TE Connectivity

Product Change Notification: PCN-24-206385

SGI1.5 TPA

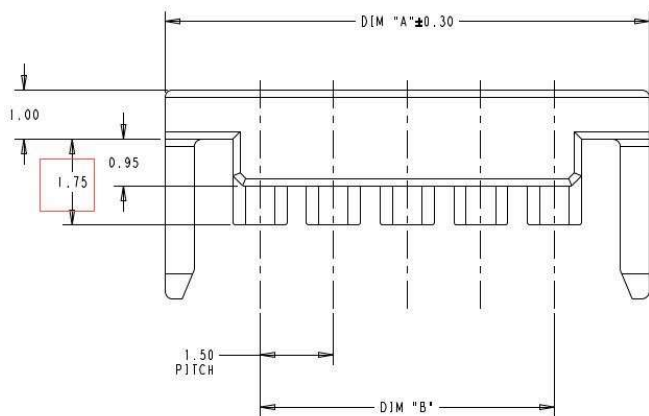
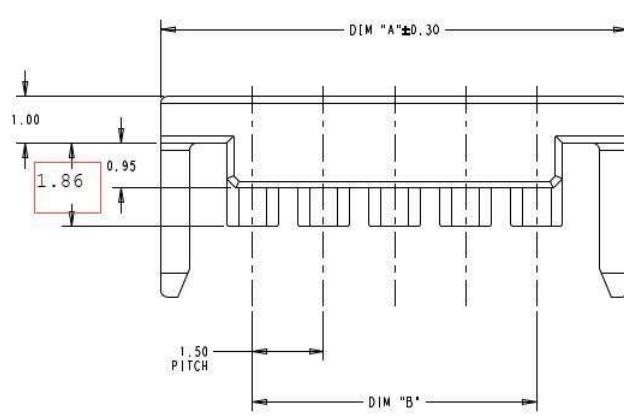
Please be aware of an upcoming feature change to the listed part numbers. Before: TPA tooth length 1.75mm. After: TPA tooth length 1.86mm

TPA tooth length 1.75mm.

TPA tooth length 1.86mm.

TPA performance optimization, which makes the TPA more robust.
